UNITED STATES PATENT AND TRADEMARK OFFICE

10/824,265

Office Action Summary

DETAILED ACTION

Figure 8

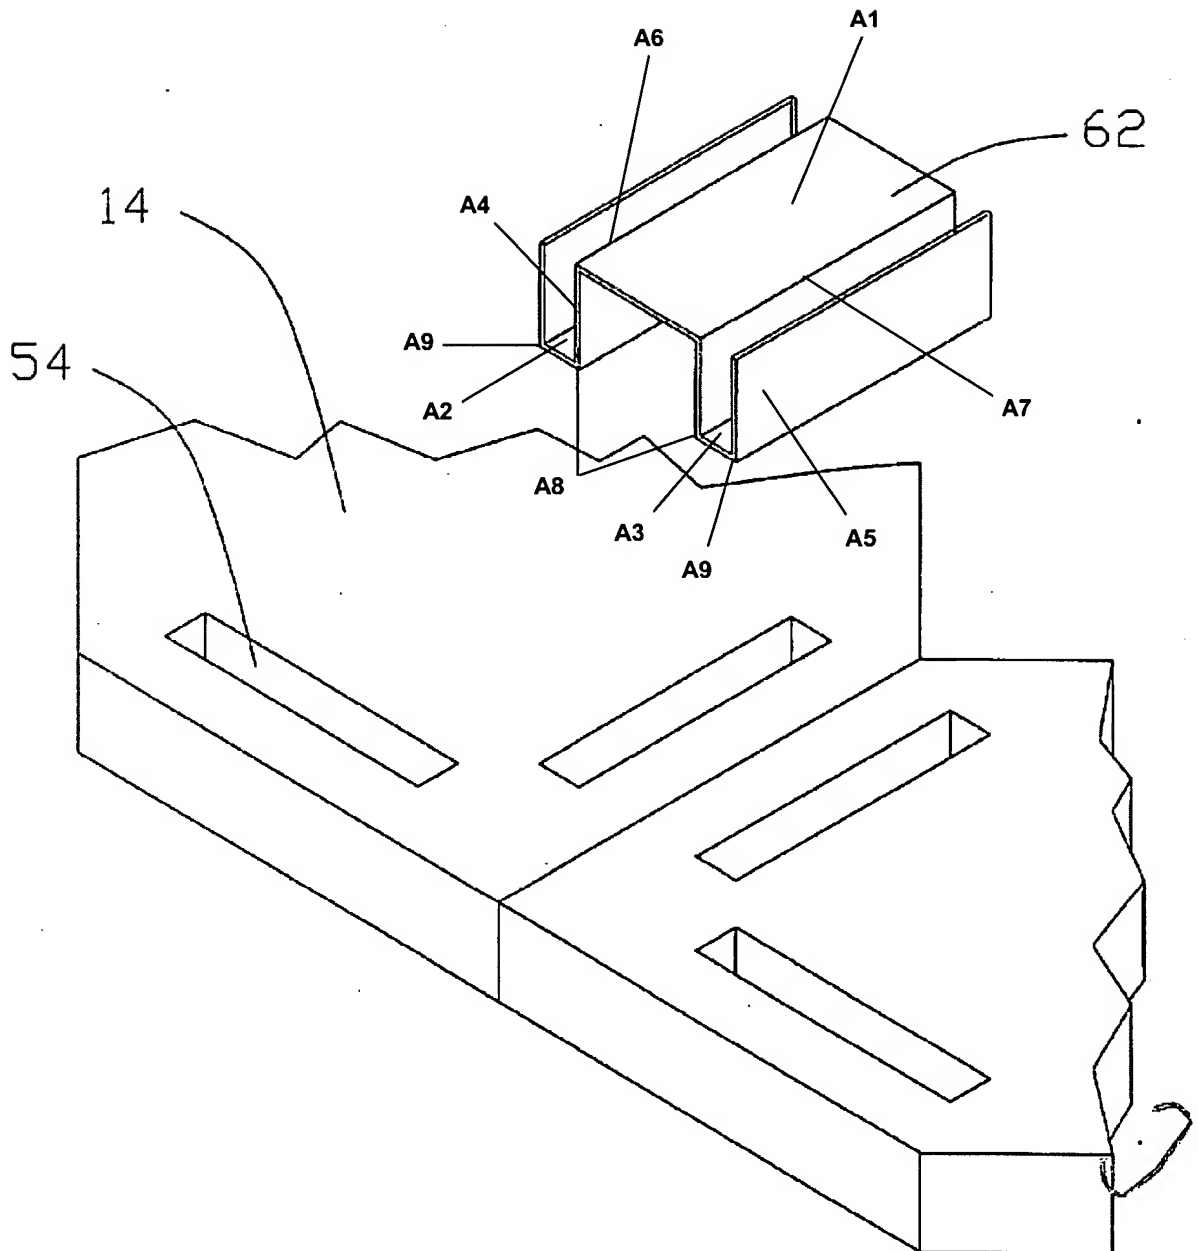
Regarding claim 1, Johnson discloses, in Figure 8, discloses a connector **62** comprising at least one two-prong connector unit comprising an upper member **A1** (see

marked-up attachment), a first lower prong member **A2**, a second lower prong member **A3**, a first joining member **A4**, and a second joining member **A5**. The upper member **A1** has a first end **A6** and a second end **A7**. The first lower prong member **A2** having an inner end **A8** and an outer end **A9**. The second lower prong member **A3** has an inner end **A8** and an outer end **A9**. The first joining member **A4** connects the first end **A6** of the upper member **A1** to the inner end **A8** of the first lower prong member **A2**. The second joining member **A5** connects the second end **A7** of the upper member **A1** to the inner end **A8** of the second joining member **A5**. The upper member **A1** is substantially parallel to the first lower prong member **A2** and to the second lower prong member **A3**.

Regarding claim 16, Johnson discloses, in Figure 8, a system comprising adjacent mat panels **14** and a connector **62**. The mat panels **14** have a hole **54** near edges. The connector **62** is inserted into the holes **54**. The connector **62** has at least one two-prong connector unit comprising an upper member **A1** (see marked-up attachment), a first lower prong member **A2**, a second lower prong member **A3**, a first joining member **A4**, and a second joining member **A5**. The upper member **A1** has a first end **A6** and a second end **A7**. The upper member **A1** lies on top of the mat panels **14** and spans the distance between the holes **54** in the adjacent mat panels **14**. The first lower prong member **A2** has an inner end **A8** and an outer end **A9**. The second lower prong member **A3** has an inner end **A8** and an outer end **A9**. The first joining member **A4** connects the first end **A6** of the upper member **A1** to the inner end **A8** of

the first lower prong member **A2**. The second joining member **A5** connects the second end **A7** of the upper member **A1** to the inner end **A8** of the second joining member **A5**. The upper member **A1** is substantially parallel to the first lower prong member **A2** and to the second lower prong member **A3**.

Regarding claims 9 and 22, the first lower prong member **A2**, the second lower prong member **A3**, the first joining member **A4**, and the second joining member **A5** are comprised of a raw material selected from metal sheets.

FIG. 5

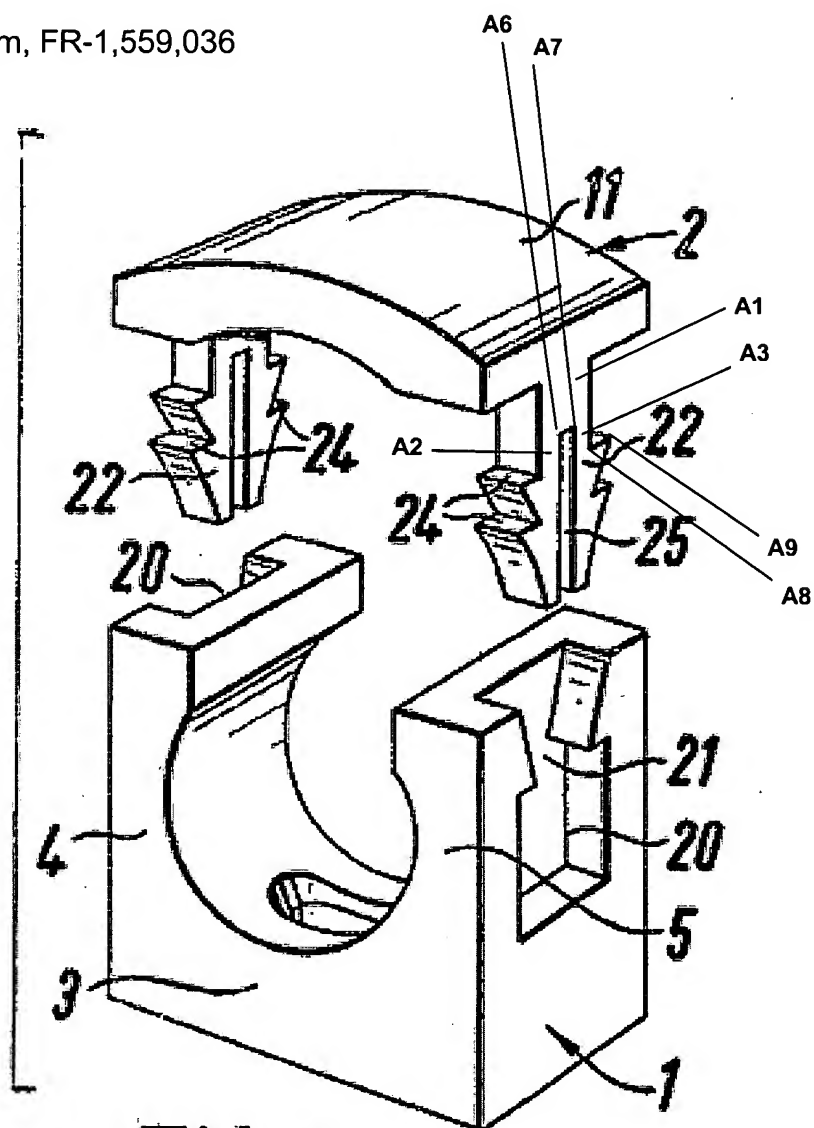
Regarding claim 1, Dom discloses, in Figure 5, discloses a connector **2** having at least one two-prong connector unit comprising an upper member **A1** (see marked-up attachment), a first lower prong member **22**, a second lower prong member **22**, a first joining member **A2**, and a second joining member **A3**. The upper member **A1** has a first end **A6** and a second end **A7**. The first lower prong member **22** having an inner end **A8** and an outer end **A9**. The second lower prong member **22** has an inner end **A8** and an outer end **A9**. The first joining member **A2** connects the first end **A6** of the upper member **A1** to the inner end **A8** of the first lower prong member **22**. The second joining member **A3** connects the second end **A7** of the upper member **A1** to the inner

end **A8** of the second joining member **A3**. The upper member **A1** is substantially parallel to the first lower prong member **22** and to the second lower prong member **22**.

Regarding claim 2, the one two-prong connector unit is joined in parallel to another two-prong connector by at least one spanning member **11** that connects the upper member **A1** of each of the of the two-prong connector units.

Regarding claim 3, the upper members **A1** are parallel and the lower prong members **24** are in the same pane as one another.

Regarding claim 15, the one spanning member **11** is connected to the upper members **A1**.

Regarding claim 30, Dom discloses, in Figure 5, discloses a connector **2** having at least one two-prong connector unit comprising an upper member **A1** (see marked-up attachment), a second upper member **A1**, a first lower prong member **22**, a second lower prong member **22**, a first joining member **A2**, a second joining member **A3**, a third lower prong member **22**, a fourth lower prong member **22**, a third joining member **A4**, a fourth joining member **A5**, and at least one spanning member **11**. The upper member **A1** has a first end **A6** and a second end **A7**. The first lower prong member **22** having an inner end **A8** and an outer end **A9**. The second lower prong member **22** has an inner end **A8** and an outer end **A9**. The first joining member **A2** connects the first end

A6 of the upper member **A1** to the inner end **A8** of the first lower prong member **22**.

The second joining member **A3** connects the second end **A7** of the upper member **A1** to the inner end **A8** of the second joining member **A3**. The upper member **A1** is substantially parallel to the first lower prong member **22** and to the second lower prong member **22**. The second upper member **A1** has a first end and a second end. The third lower prong member and the fourth lower prong member have an inner end and an outer end. The third joining member connects the first end of the second upper member to the inner end of the third lower prong member. The second upper member is substantially parallel to the third lower prong member and substantially perpendicular to the third joining member. The fourth joining member connects the second end of the second upper member to the inner end of the fourth lower prong member. The second upper member is substantially parallel to the fourth lower prong member and substantially perpendicular to the fourth joining member. The spanning member connects the first upper member **A1** to the second upper member **A1**. The first upper member and the second upper member are parallel to one another and the prong members **22** are in the same plane as one another.

Fig. 5.

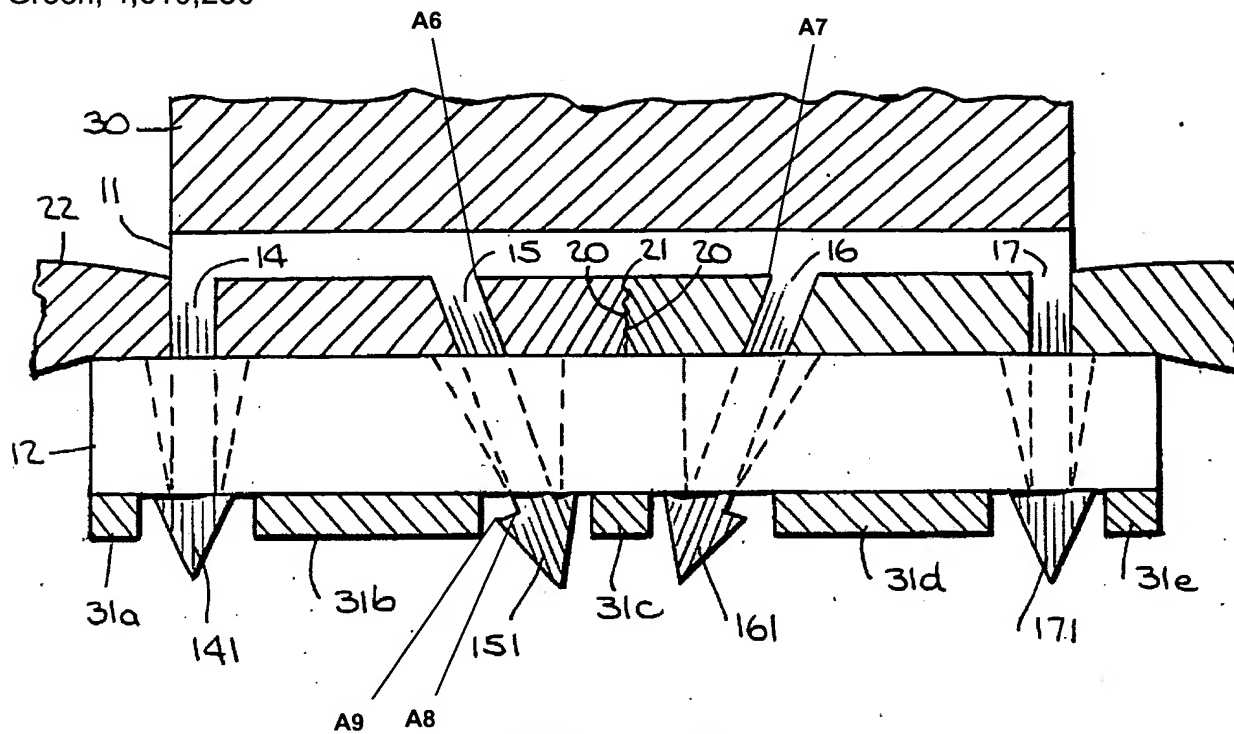
Regarding claim 1, Green discloses, in Figure 5, discloses a connector having at least one two-prong connector unit **11** comprising an upper member **13**, a first lower

prong member **151**, a second lower prong member **161**, a first joining member **15**, and a second joining member **16**. The upper member **13** has a first end **A6** (see marked-up attachment) and a second end **A7**. The first lower prong member **151** having an inner end **A8** and an outer end **A9**. The second lower prong member **161** has an inner end **A8** and an outer end **A9**. The first joining member **15** connects the first end **A6** of the upper member **13** to the inner end **A8** of the first lower prong member **151**. The second joining member **16** connects the second end **A7** of the upper member **13** to the inner end **A8** of the second joining member **16**. The upper member **13** is substantially parallel to the first lower prong member **151** and to the second lower prong member **161**.

Regarding claim 6, an internal angle between the upper member **13** and the first joining member **15** is less than ninety degrees and an internal angle between the upper member **13** and the second joining member **16** is less than ninety degrees.

FIG. 8A

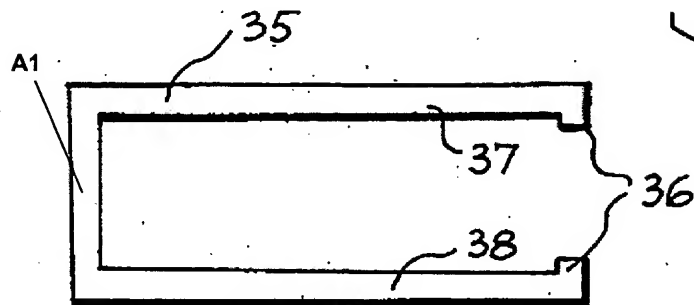
Regarding claim 16, Brown discloses, in Figures 8A and 8B, a system comprising adjacent mat panels **13** and a connector **35**. The mat panels **13** have a hole **14** near edges. The connector **35** is inserted into the holes **14**. The connector **35** has at least one two-prong connector unit comprising an upper member **A1** (see marked-up

attachment), a first lower prong member **36**, a second lower prong member **36**, a first joining member **37**, and a second joining member **38**. The upper member **A1** has a first end and a second end. The upper member **A1** lies on top of the mat panels **13** and spans the distance between the holes **14** in the adjacent mat panels **13**. The first lower prong member **36** has an inner end and an outer end. The second lower prong member **36** has an inner end and an outer end. The first joining member **37** connects the first end of the upper member **A1** to the inner end of the first lower prong member **36**. The second joining member **38** connects the second end of the upper member **A1** to the inner end of the second joining member **38**. The upper member **A1** is substantially parallel to the first lower prong member **36** and to the second lower prong member **36**.

Regarding claim 20, the internal angle between the upper member **A1** and the first joining member **37** is at least ninety degrees and the internal angle between the upper member **A1** and the second joining member **38** is at least ninety degrees.

Regarding claim 22, the first joining member **37** and the second joining member **38** are comprised of metal sheets.
